North-South 400kV Interconnection Development

**Response to the
Issues Raised in
Submissions /
Observations**

Figure 5.1 Options for Line Straight 105-109 (Towers 107 – 109)

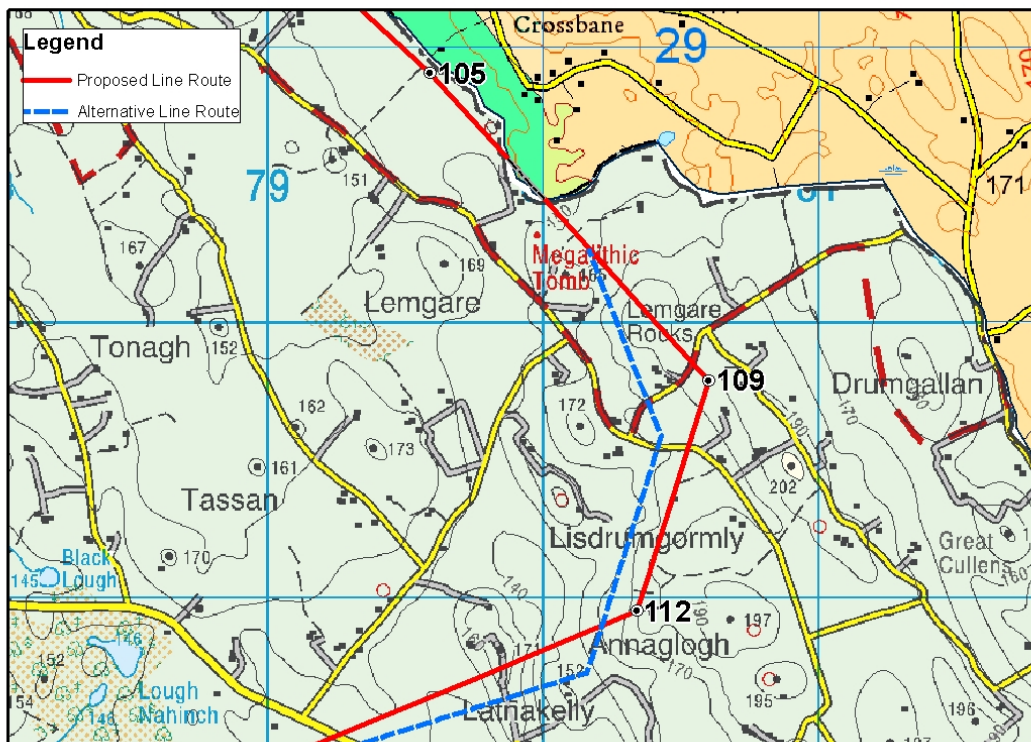
177 The line route is sited in this area to travel along the lower contours in a south-easterly direction in the townland of Lemgare and to minimise the number of line straights within this section. In addition it is also routed to avoid a house in the vicinity of the oversail section between the two jurisdictions and the one off houses at the road crossing in Lisdrumgormly (**Figure 5.1**). The line design has been optimized to ensure that the minimum amount of towers are used within the line straight. The siting of towers on the drumlins of the alignment occurs due to design constraints.

178 Re-siting towers 107 to 109 onto a lower contour would introduce an additional line straight and angle tower in order to avoid the drumlin at Lemgare Rocks. Moreover, an additional intermediate tower may also be merited within this section. The line route would still traverse the Monaghan Way and marginally cross mid contour to the west of Lemgare Rocks. The line route would also be routed in close proximity to large poultry sheds.

Figure 5.2 Options for Line Straights 112-116,116-118,118-121,121-126 (Towers 112, 114, 116-125)

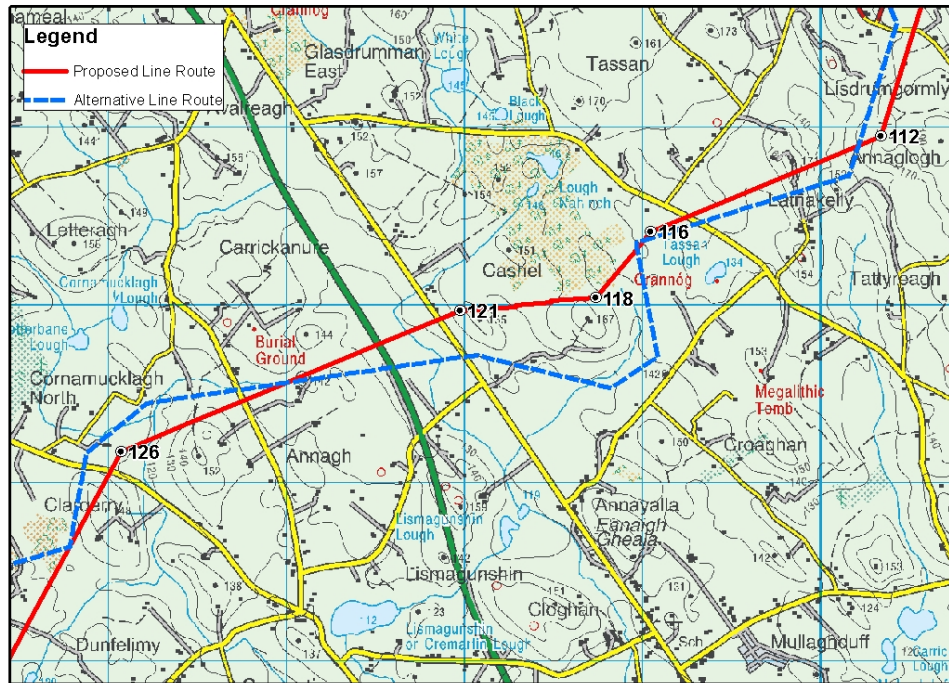
181 Re-siting tower 112 and 114 off the contour would bring the line straight closer to Tassan Lough and the geological interest area located to the east of the Lough (**Figure 5.2**). The line route would still be located mid-contour and sited closer to a number of outbuildings. Re-siting Tower 116 to 118 would locate the OHL route closer to the above listed constraints.

184 The alternative routing would, therefore increase by two the number of line straights and angle towers and would place OHL marginally closer to the environmental constraints. The number of additional intermediate towers may also increase by one.

Figure 5.3 Options for Line Straights 3112-116,116-118,118-121,121-126, Towers 112, 114, 116-125

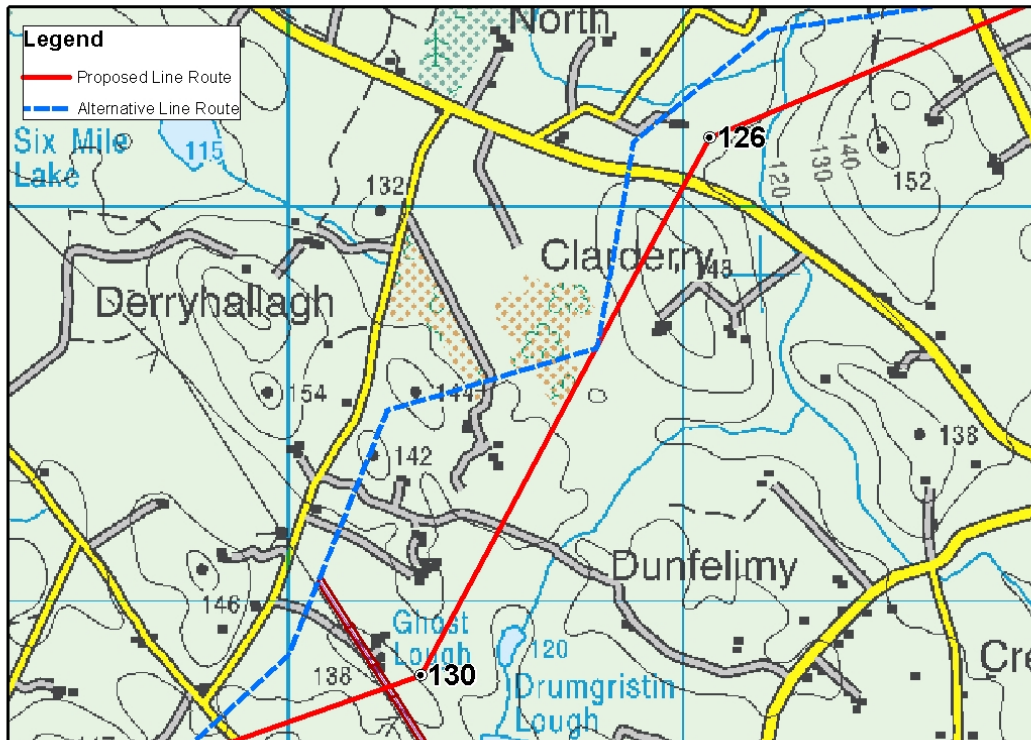
186 The line route is sited in this area in order to avoid the cutover bog at Clarderry, the drumlin in Derryhallagh and the lakes to the south namely Ghost, Drumgristin and Coogan Loughs. One off housing had to be avoided in the line route selection process. In addition the proposed alignment is routed in order to obtain at an optimum crossing of the existing Lisdrum-Louth 110kV line. The line design has been optimized to ensure that the minimum amount of towers are used within the line straights. The siting of towers on the drumlins of the alignments occurs due to design constraints.

187 An alternative route would place the line route further to the west of the current alignment in the townland of Derryhallagh (Monaghan By) see Figure 3. Re-siting tower 127 of the drumlin would introduce an additional angle tower and line straight. Clarderry bog would have to be traversed if the alternative route to the west was selected. In addition, three additional lane ways would have to be crossed and the line would be placed in closer proximity to a number of houses in the townland of Derryhallagh (Monaghan By) and Lennan. The alternative route would increase the number of line straights and angles by two each. The number of additional intermediate towers may also increase by one.

Figure 5.4 Options for Line Straights 132-136,136-140,140-142 and 142-149 (Towers 133,134,137,139,141,144 and 146-150)

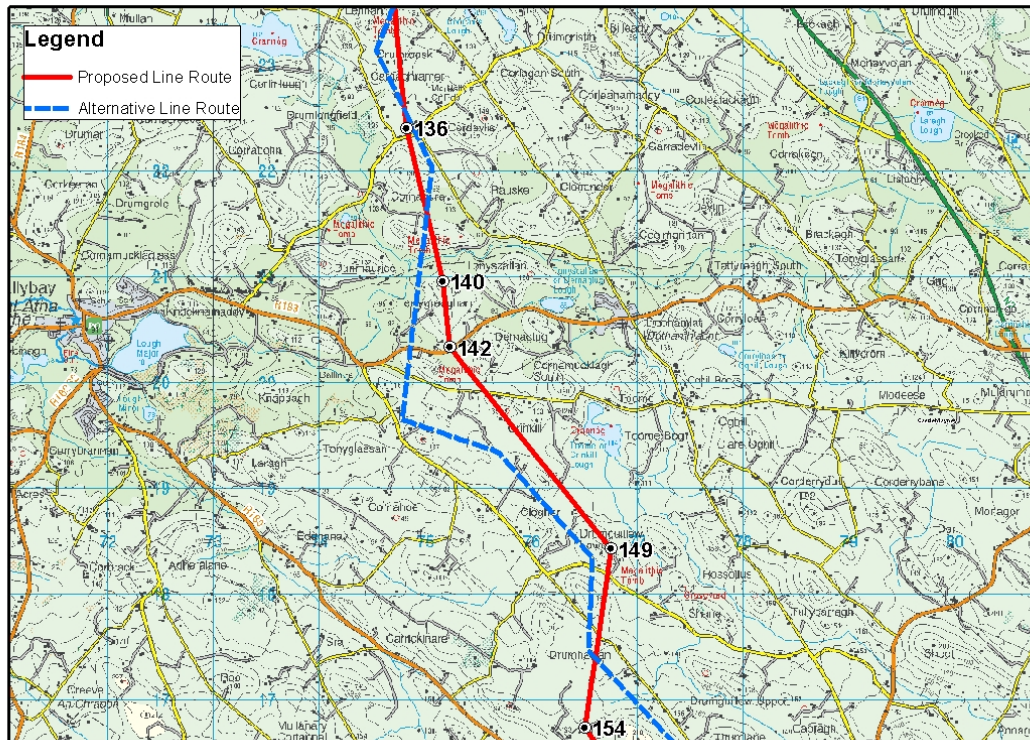
- 191 In Monaghan County Council's submission the question is raised also whether the line route in the vicinity of Crinkill or Toome Lough could be routed further away. An alternative route would continue from the church and cross two additional lanes within the townland of Clogher. The line route would then be located on the mid contour in the townland of Clogher and Drumguillew Lower.

- 190 Siting tower 133, 134 and 137 of the drumlin would require another dogleg in the alignment at tower 132 and require alternative an angle tower in close proximity to the megalithic tomb in the townland of Lennan (see **Figure 5.4**). The alternative line route would run parallel with the Rausker road and then deviate in the townland of Cornanure (Monaghan By) and cross the drumlin in the same townland and skirt along a lower contour in the townland of Terrygreeghan. The alternative alignment would then cross an additional lane and be sited on the lower contour to the south of the R183 Ballybay – Castleblayney regional road also in the townland of Terrygreeghan and travel in close proximity between two large slatted sheds before changing direction in the townland of Tonyglasson (ED Greagh) in very close proximity to the R.C. Church in Tullycorbet.

- 192 In summary the alternative line routing between tower 132 and 149 would increase the number of line straights by one and angle towers by one. It would cross three additional lanes and be sited in very close proximity to the church in Tullycorbet. The number of additional intermediate towers may also increase by one.

Figure 5.6 Options for Line Straights 1149-154 (Tower 149-154)

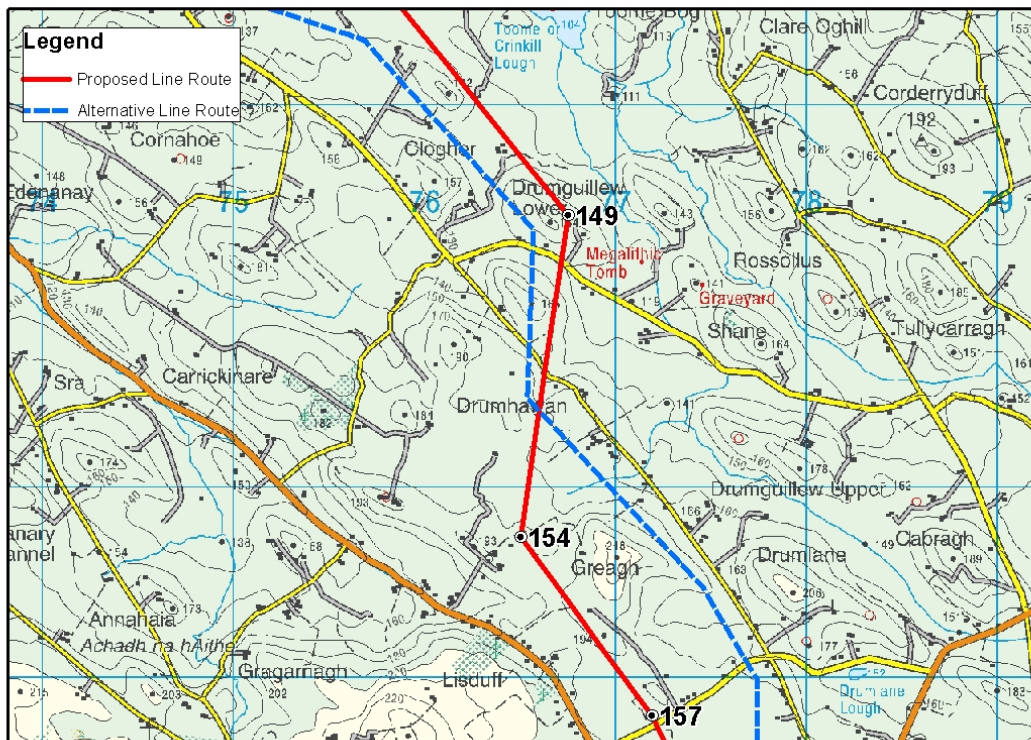
195 The movement of tower 149 and 150 to the west of current location would place the towers on the opposite mid contour in the townland of Drumguillew Lower and then the alternative route would have to cross another drumlin in the townland of Drumhowan to south of road and continue in a southerly direction where tower 153 would be sited marginally to the west of the current location (see **Figure 5.6**) and then run in a south easterly direction running parallel to a minor road where one off houses occur.

196 In summary the alternative line routing between Towers 149 -154 would increase the number of line straights by one and angle towers by one. The number of additional intermediate towers may increase by one.

Figure 5.7 Options for Line straights Tower 154 -159

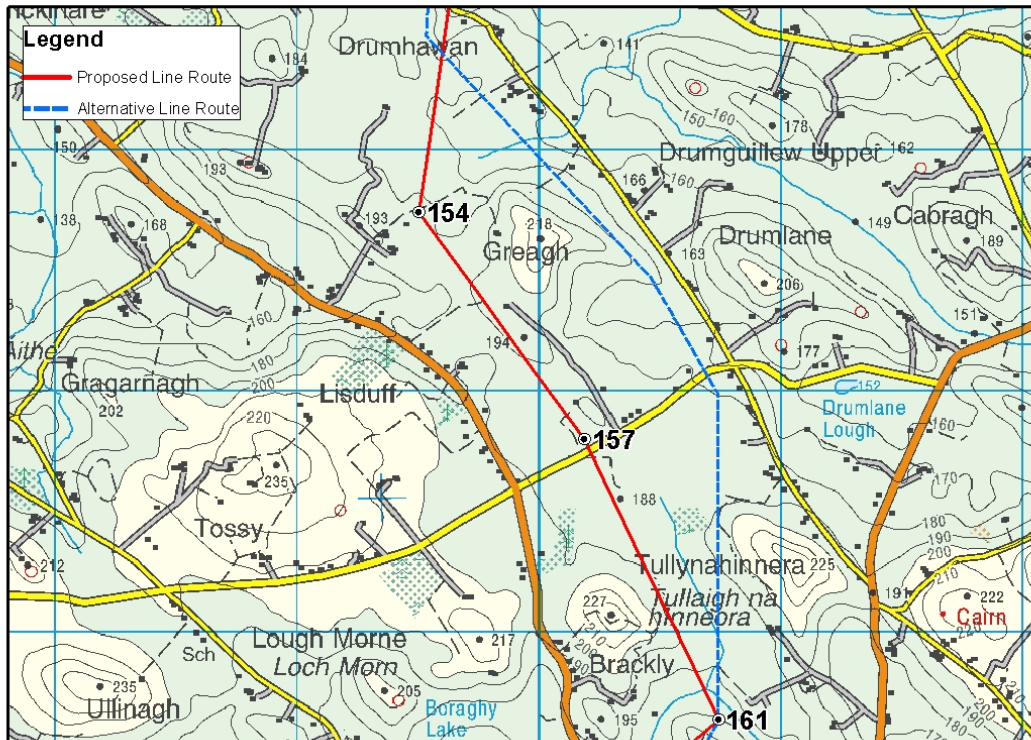
200 Moving the alignment to the east in the townland of Greagh (Cremorne By) would place the line on mid contour and also this would be replicated in the townland of Tullynahinnera (see **Figure 5.7**). Moreover, the line route would be placed closer to the scenic route north of Lough Egish with the addition of running the line parallel to the local road in the townland of Drumhawan and Drumlane. Moving the line route to the west of the current alignment between tower 154 and 161 would place the alignment in very close proximity to one off housing and it will also stay within the upland farmland zone.

201 Overall the alternative line considered to the east of the current alignment will bring the line route closer to a lot more housing along the minor roads and closer to the scenic route. The number of additional intermediate towers may increase by one.

Figure 5.8 Options for Line straights 161- 166, 166-169 Tower 164, 166, 167

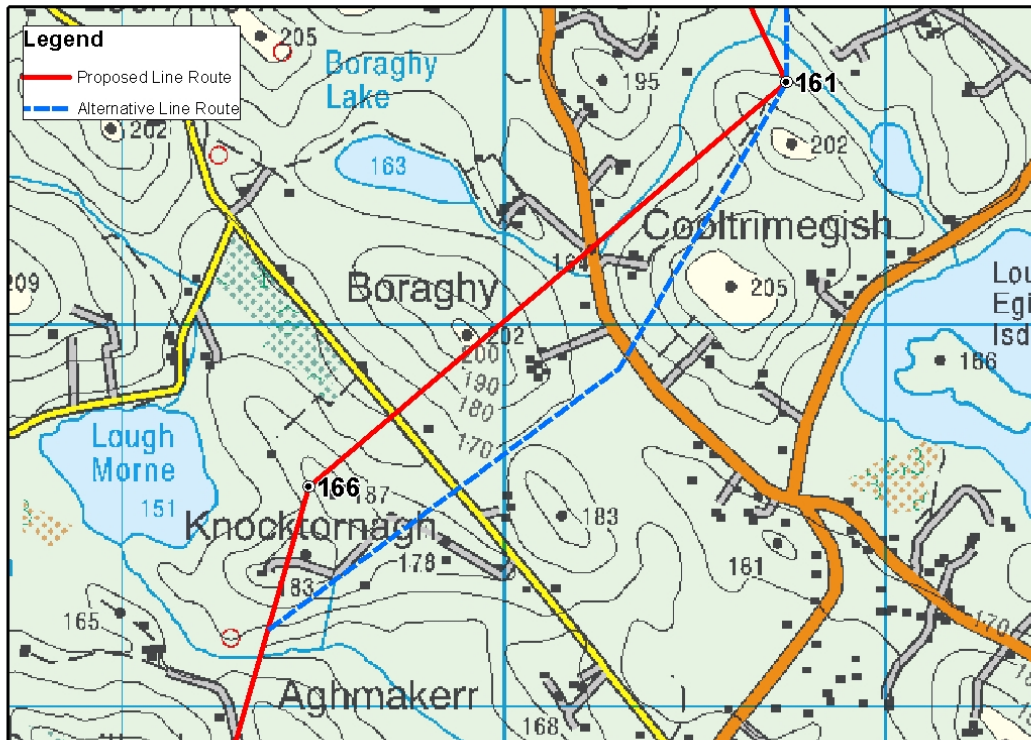
203 The line route is sited in this area to avoid the ribbon development which occurs on the main R180 from Lough Egish and the scenic route north of Lough Egish. The line design has been optimized to ensure that the minimum amount of towers are used within the line straight. The siting of towers on the drumlins of the alignment occurs due to design constraints.

204 The line route can be routed to the east (see **Figure 5.8**). In addition the line route would cross mid contour on the drumlin in the townland of Cooltrimegish and Aghmakerr. The alternative line route to the east would increase the number of line straights by one and angle towers by one. It is anticipated that no new intermediate towers would be required for the alternative line route section.

Figure 5.9 Options for Line straights 169-176, 176-181, Tower 171-176, 179

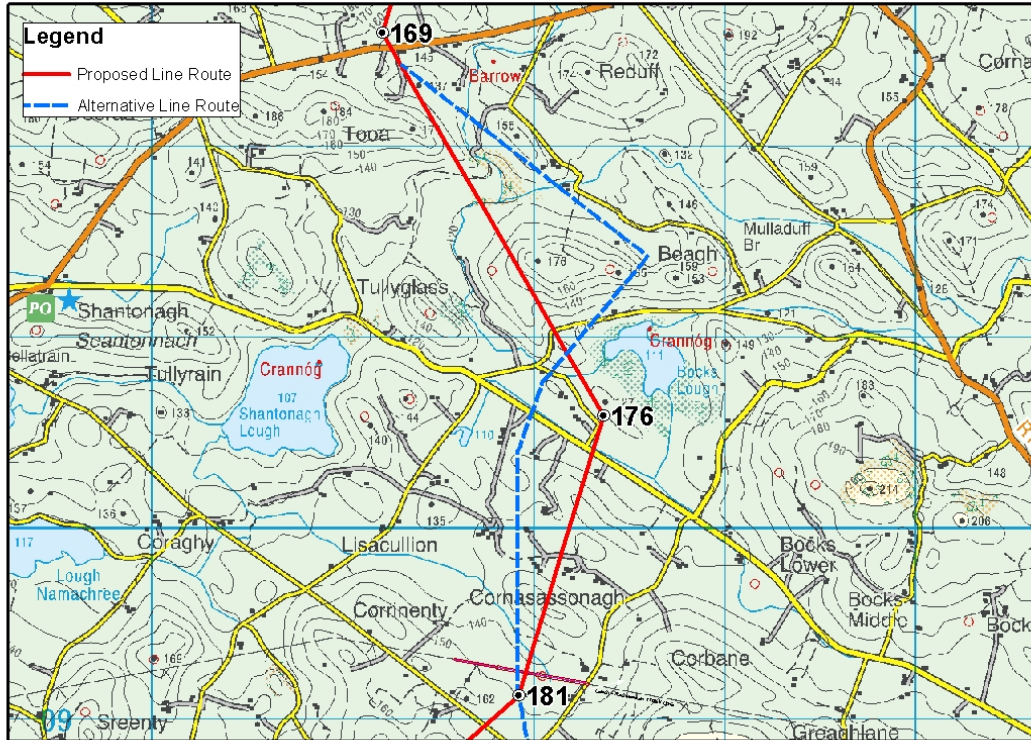
207 An alternative route would commence from Tower 169 and travel to the southeast through the townlands of Tooa, Tullyglass and Beagh (Cremorne By) and run in close proximity to the road in Beagh and the mill which is located adjacent to the road (see Figure 5.9). It would then deviate at close to 90 degrees to avoid the ringfort in the townland of Beagh (Cremorne By) and cross to the north of Bock's Lough and cross on the mid contour. The alternative line routing between Towers 169 -181 would increase the number of line straights by three and angle towers by three.

- 208 An alternative route to the west of Bocks Lough to circumvent Bock's Lough would exist which would cross two roads where one-off housing is prevalent. The line route in this section would continue on to Tower 181 and would still cross mid contour on the drumlin in the townland of Cornasassonagh. It is anticipated that no new intermediate towers would be required.

Figure 5.10 Options for Line Straights 181-184 Tower 182,183

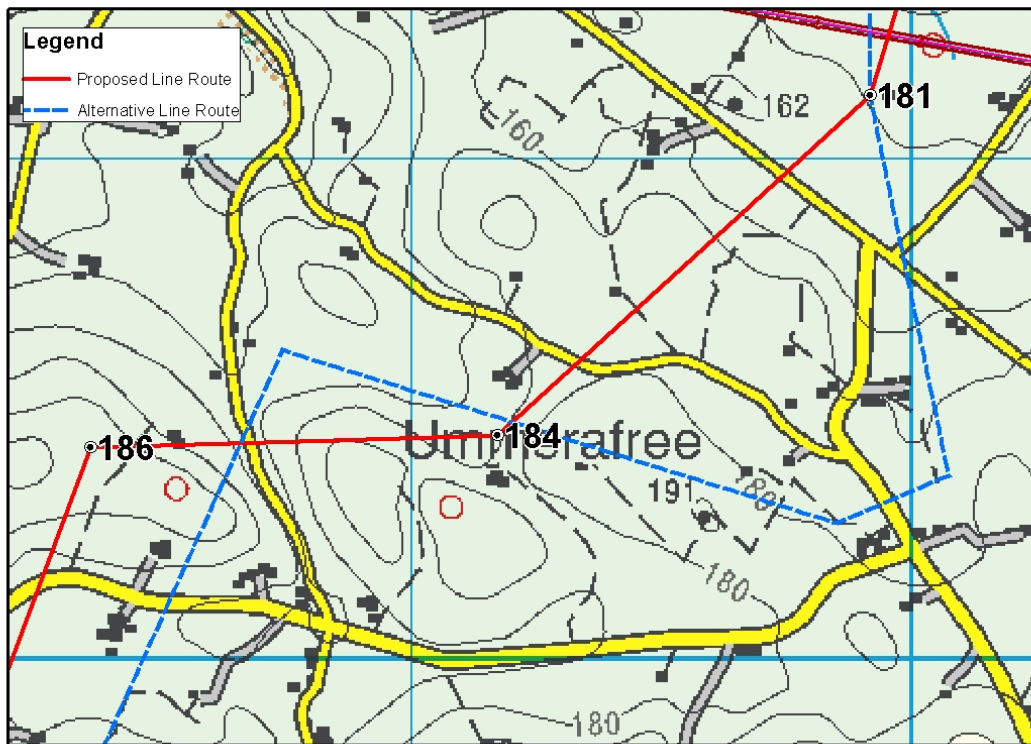
- 210 The line route is routed in this area to avoid one-off housing.
- 211 An alternative line route to the east of the current alignment is viable which crosses three minor roads and would be located on the ridge and plateau in the townland of Ummerafree (see Figure 5.10). The route would traverse due south from Tower 181 crossing two minor roads and turn 90 degrees to the west to avoid housing and extend through Tower 184 for a distance of 400m. Moreover, if the alternative route was adopted the number of line straights would increase by two and the number of angle tower would also increase by the same number. It is anticipated that two additional intermediate towers may be required.

Figure 5.11 Options for Line Straights 186-188, 188-197 Tower 186-191, 193, 194

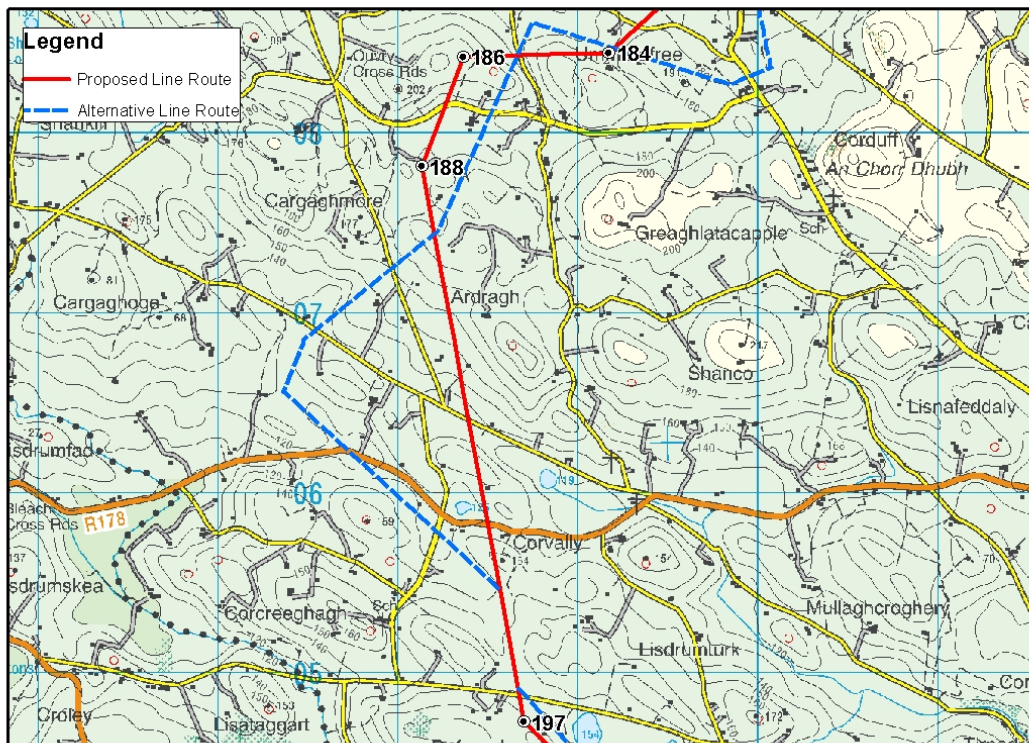
214 A viable alternative route within this section of line route exists (see **Figure 5.11**) and would deviate from Tower 184 and travel in a north-westerly direction meandering between the drumlins in the townland of Ummerafree, where an angle tower would be sited, and then head in the south-westerly direction crossing on a lower contour between the townland of Ummerfree and Sreenty before deviating south of Tower 188 and proceed in a south-westerly direction crossing two minor roads and deviating slightly once again to avoid the drumlin in the townland of Coevally (Farney By). The alternative line route would then run in a south-easterly direction, crossing the regional road R178 and a minor road and then meet up in proximity to Tower 195, located approximately 500m south of

- 215 If the aforementioned alternative route was selected, it would introduce three additional line straights and three angle towers. The alternative alignment would also be located closer to the school in the townland of Corcreaghagh. Thus, as can be appreciated, the current alignment significantly reduces the number of line straights within the receiving environment. The current alignment is routed insofar as possible off the main contours within this section. It is anticipated that one new additional intermediate tower may be required.

Figure 15.1: EIS Figure 9.2: Audible noise from single circuit 400 kV towers

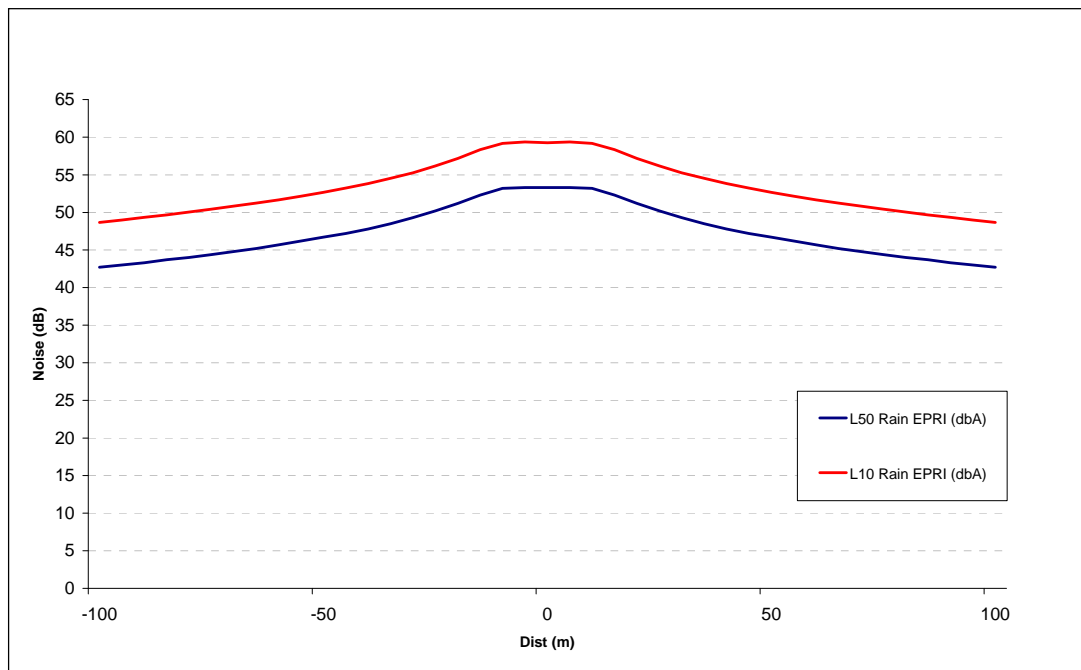
- 17 In fair weather, corona sources are sufficiently few in number that this noise is generally of no concern and is often inaudible to people on the ground. Corona noise attains higher levels and may become audible in wet weather, when large numbers of corona sources form as water droplets on the conductors as seen in Figure 9.2, extracted from Chapter 9, Volume 3C and 3D of the EIS below.

- 18 However, on such occasions, the background noise level of rainfall and wind tend to mask the noise from the transmission line. People are likely to find any noise from a high voltage line to be more noticeable during periods of light rain, snow or fog when they are more likely to be outdoors, or to have windows open, and when the background noise is generally lower, than would be the case during heavier rain.
